**ATTACHMENT 10**

**City of Port Phillip Internal Referral Responses RE: 04-10-2021 Drawings**

**276-284 Ingles St, PM: DELWP Ref: PSA C201port, CoPP Ref: 1/20121/MIN**

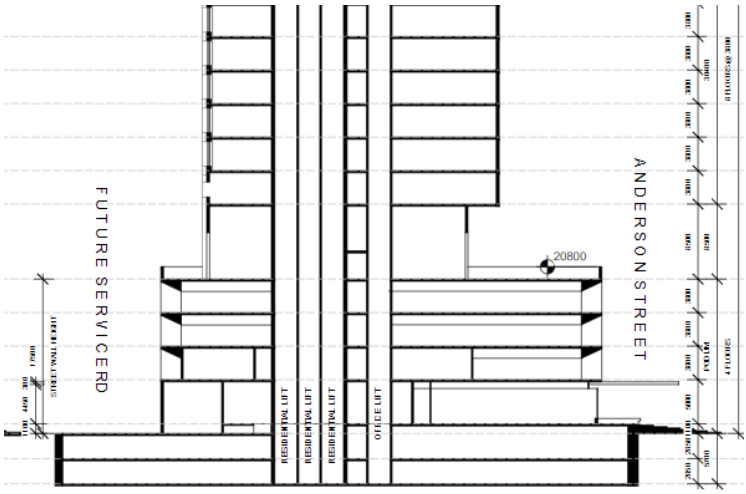
- Evidence that wind management treatments will successfully achieve required wind criteria.
4. In response to you and Brendan’s comment that “the reduction in articulation of the top 3 tower elements is reduction in design quality for significant new landmark building on the skyline. A greater difference in heights should be re-instated as per earlier schemes”. I note that it appears some additional height may be possible without compromising the mandatory overshadowing requirements (North Port Oval; as indicated in the shadow diagram below).

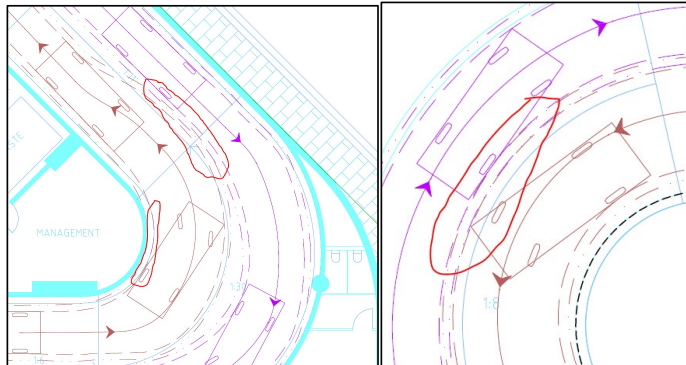
<p><b>Traffic/Parking</b></p>	<p><b>Proposal:</b></p> <ul style="list-style-type: none"> <li>• Construction of a multi-level mixed use tower comprising of:             <ul style="list-style-type: none"> <li>- 122 x one-bedroom dwellings.</li> <li>- 111 x two-bedroom dwellings.</li> <li>- 60 x three-bedroom dwellings.</li> <li>- 391m<sup>2</sup> (gross floor area) retail tenancy.</li> <li>- 6,616m<sup>2</sup> (gross floor area) office space.</li> </ul> </li> <li>• The proposal includes a two-level basement carpark comprising of 196 parking spaces.</li> <li>• Access is proposed via Ingles Street.</li> <li>• 2 x loading areas are proposed on-site.</li> <li>• 1 x waste loading area is proposed on-site.</li> <li>• 412 bicycle parking spaces are proposed on level 1 for commercial staff and residents.</li> <li>• 38 bicycle parking spaces are proposed on the ground floor external to the building for visitors.</li> </ul> <p><b>Car Park Layout:</b></p> <p><b>Access ways:</b></p> <ul style="list-style-type: none"> <li>• Access to the site is proposed via a modified vehicle crossing on Ingles Street.</li> <li>• The width of the access point at the property boundary is dimensioned as 9.403m. This is acceptable.</li> <li>• The circular ramp is dimensioned as 6m wide. The width of the kerb on either side is unknown. The applicant is to show this dimension.</li> <li>• The detailed design of the circulation ramp is not shown on the plans, therefore an assessment cannot be determined if the circular ramp accords with the Australian Standard.</li> <li>• Swept path diagrams have been provided demonstrating a B85 and B99 vehicle simultaneously passing each other on the circulation ramp (although two B99 vehicles was initially requested). Notwithstanding, a review of the swept paths provided raise concern due to the intensity of the development and frequency of traffic. Below marks tight areas were two vehicles encroach into the 300mm clearance area and showing the wheel/body path travelling along the kerb.</li> </ul>

- It is therefore recommended that the circulation ramps be widened to comfortably allow a B99 vehicle and a B85 vehicle to pass each other.
- As per previous comments, we have concerns of the functionality and driver's safety. Depending on the design, the circulation creates a continuous sight line concern. In addition, the entry and exit points at all levels should have corner splays for drivers' sightlines.

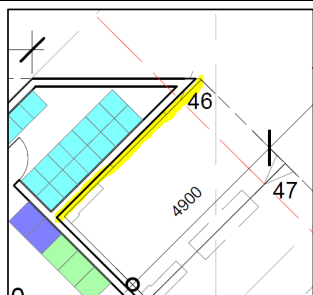
- The TIA notes that a 500mm clearance between tandem bays have not been provided and recommends the plans be updated to show this requirement. This is considered necessary and the recommendation made in the TIA is to be implemented.
- Clearances in accordance with Clause 52.06 have not been strictly applied to parking spaces abutting walls/obstructions. Therefore, recommendations made in the TIA to amend the design in accordance with the Planning Scheme is to be adopted. In cases where full compliance is not achieved, the applicant is to confirm the functionality of the design by providing B85 swept path diagrams to all critical spaces (example shown below).
